PRODUCT CHANGE NOTICE

1. TITLE Case Outline Lead Finish, Ceramic LCC style		2. DOCUMENT NUMBER FV5-C-12-006
		3. DATE August 27, 2012
4. MANUFACTURER AND ADDRESS International Rectifier 205 Crawford Street Leominster, MA 01453		5. MANUFACTURER PART NUMBER NA / LCC package types shown below

FV5-C-12-006

Figure 1 – Residue in Castellation, post steam age and solderability

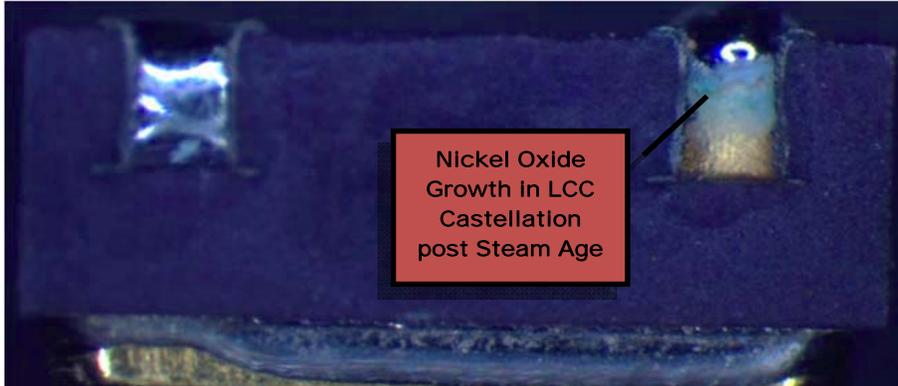
International Rectifier is experiencing solderability failures with their LCC-28, LCC-18, LCC-6, and LCC-4 style packages due to non-wetting in the lead castellation when tested in accordance with MIL-STD-750, TM2026 which invokes IPC/EIA J-STD-002, Category 3, Test B methods. The solder fails to wet at least two thirds of the way up the castellation, as required by J-STD-002. The failed leads often exhibit a visible nickel oxide (white or blue residue), which is usually concentrated in the castellation. (See figure 1 herein for exhibit). The nickel oxide is not removed by the RMA type flux specified in the solderability test method and inhibits wetting of the solder to the gold lead.

The LCC leads have exposed Nickel and Tungsten (LCC package base metals) at the castellation edges, which is inherent with the package design due to singulation. Before any steam aging is performed, the LCC package castellation does solder and wet properly (even with no use of flux). However when performing solderability testing on the gold leads, the exposed base metals can oxidize during steam age and contaminate the castellation lead surface, leading to non-wetting of the gold surface.

While International Rectifier has not received any reports of solderability failure from the field, we are taking this improvement action of pre-tinning the parts before delivery to effectively prevent the growth of oxides in the field or during long term storage. The problem described herein is not new and not just specific to International Rectifier, but is common to the user community of the LCC package styles.
